**HERITAGE IMPACT ASSESSMENT
IN RESPECT OF THE PROPOSED UPGRADING/IMPROVEMENT
WORKS FOR FEATURE NO. 11SW-B/R93 (SUB-DIVISION NO. 1) NEAR
DUDELL STREET STEPS AND GAS LAMPS**

**SUPPLEMENTARY PAPER ON THE
REVISED DESIGN OF THE PROPOSED UPGRADING/IMPROVEMENT
WORKS FOR FEATURE NO. 11SW-B/R93 (SUB-DIVISION NO. 1),
DUDELL STREET**

Highways Department

September 2018

Feature No. 11SW-B/R93, Duddell Street

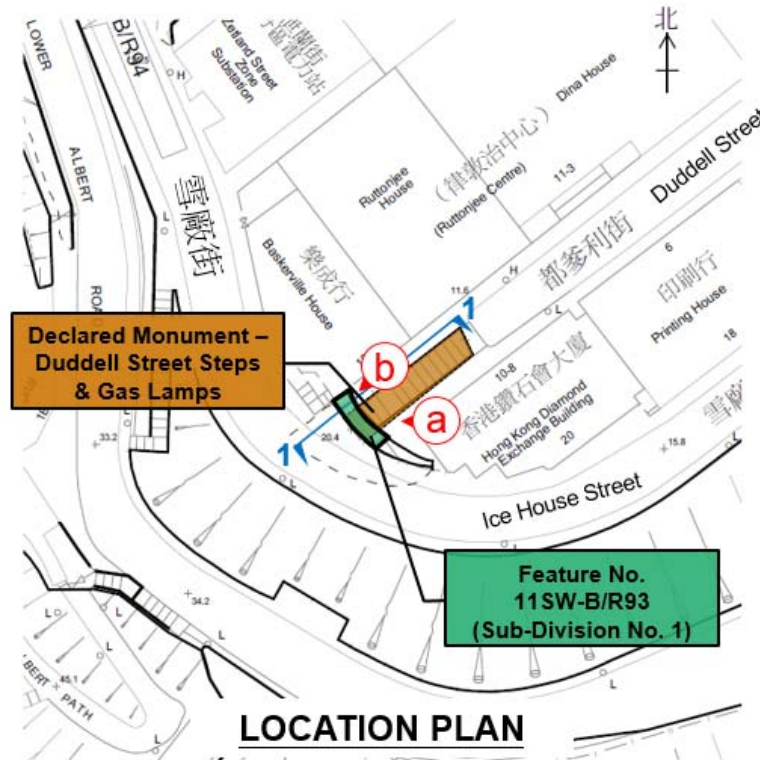
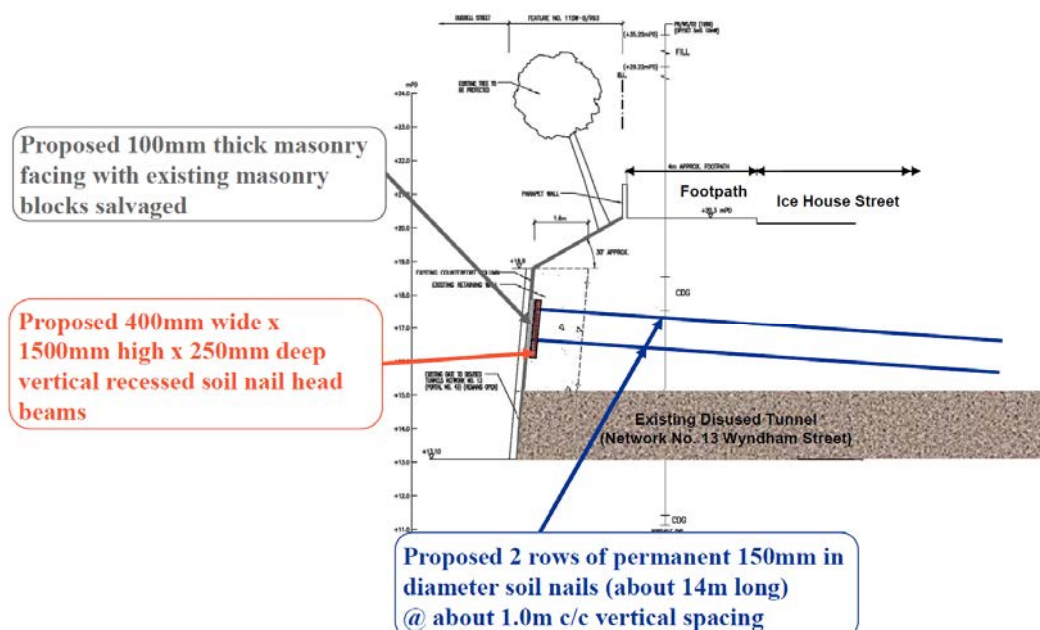
1. This supplementary paper presents the revised design of the captioned Upgrading/Improvement (“U/I”) works (“the revised design”) in response to the following concerns raised by Members of the Antiquities Advisory Board (“AAB”) at its meeting held on 27 June 2013:

3. After thorough study and review, a revised design, which mainly consists of installation of 6 nos. of soil nails of approximately 14m long at about 1m centre-to-centre horizontal and vertical grid pattern with vertical **recessed** soil nail head beams, is proposed to improve the safety standards of the man-made Feature No. 11SW-B/R93 (Sub-division No. 1). The major design revisions are:

- (a) The number and length of the proposed soil nails are reduced;
- (b) The originally proposed skin walls are replaced by vertical recessed soil nail head beams;
- (c) The affected masonry blocks of the retaining wall will be salvaged and reinstated as the proposed masonry facing; and
- (d) The existing portal entrances of the disused tunnels under the retaining wall will be preserved in situ.

The revised design consists of **recessed** vertical tie beams instead of the originally proposed skin walls. This significantly reduces the extent of the retaining wall to be affected by the proposed works. The affected masonry blocks will firstly be taken down, labelled, protected and stored before the proposed recessed vertical tie beams are constructed. After the completion of the works, the retaining wall will be reinstated with the salvaged masonry blocks trimmed to match the existing finishing surface with the recessed vertical tie beams covered by the masonry blocks. There will only be minor change to the appearance of the retaining wall upon completion of works due to proximity of cutting of the masonry blocks to the tree roots locations. The proposed works will echo with the existing appearance of the retaining wall and avoid damage to the wall tree roots as far as practicable.

During the construction, all soil nails will be constructed with hand coring (first 6m depth) and left-in casing (at least 4m in length). The tips of the lowest rows of soil nails will not penetrate the disused tunnels as well as the portals. The vibration generated will be minimised during construction of soil nails. No significant disturbance will be induced to the existing disused tunnels, which were backfilled decades ago, and Portals Nos. 43 & 44 during and after the proposed U/I works which will be further discussed in sub-section (d) below.

With due consideration of overall stability, public safety and heritage conservation for the disused tunnels in the long term, **reversible methods** will be employed to backfill the disused tunnels, while the portal entrances will be retained in situ.

- Proposed upgrading works (at Sub-Division No. 1):
 - Installation of soil nails with vertical recessed soil nail head beams
